## Task Force 2 – Receptacles

### Recommendation for Part I: Statement of technical rationale and justification

## Recommendation for Part II: Text of the regulation

Figure 1 — H35 Hydrogen receptacle

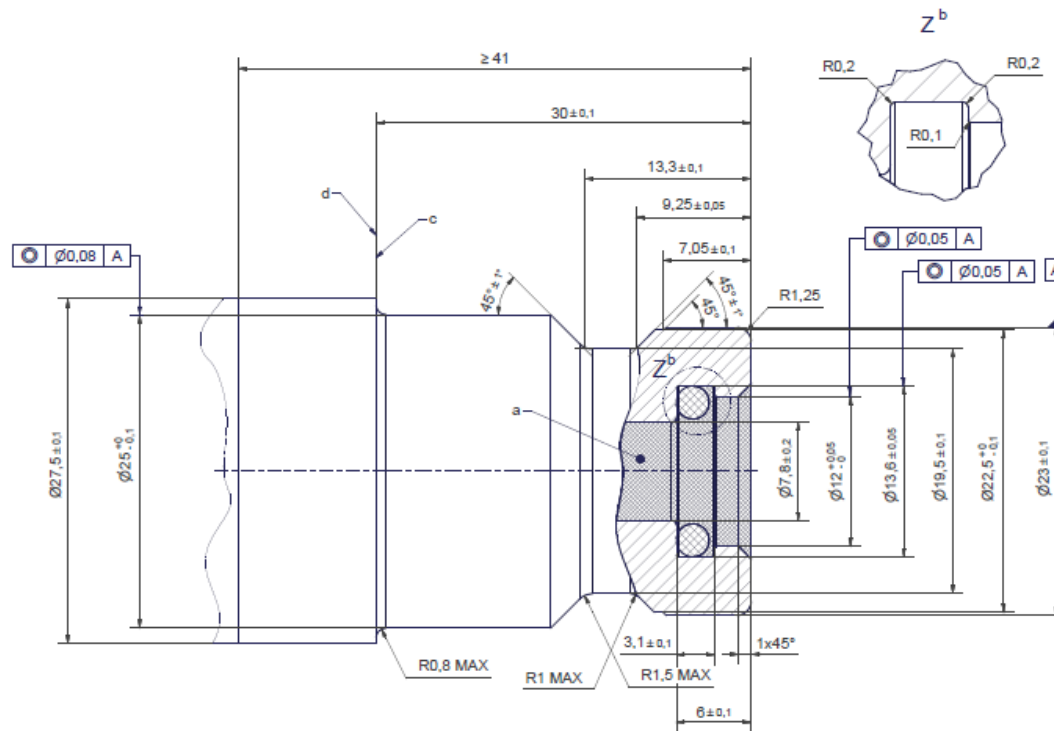
5.2.1.1.1 The fuelling receptacle shall prevent reverse flow to the atmosphere. Test procedure is by visual inspection. The geometry of the fuelling receptacle shall be designed as specified in figures 1-4. Alternatively, another design can be chosen if the receptacle geometry design provides, at a minimum, the same level of safety and interoperability as the design shown in ISO 17268:2019. In that case it shall also be ensured, e.g., by additional means, that fuelling with a higher NWP nozzle cannot be made with lower NWP receptacle designs. Figure 5 is presented as an example countermeasure against nozzle-receptacle freezing issues.

**Figure 5 — Example hex design**

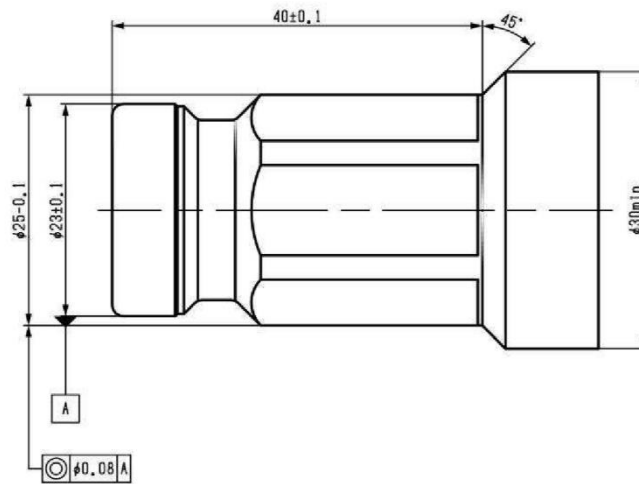
Note: This design is an example countermeasure against freezing issues.
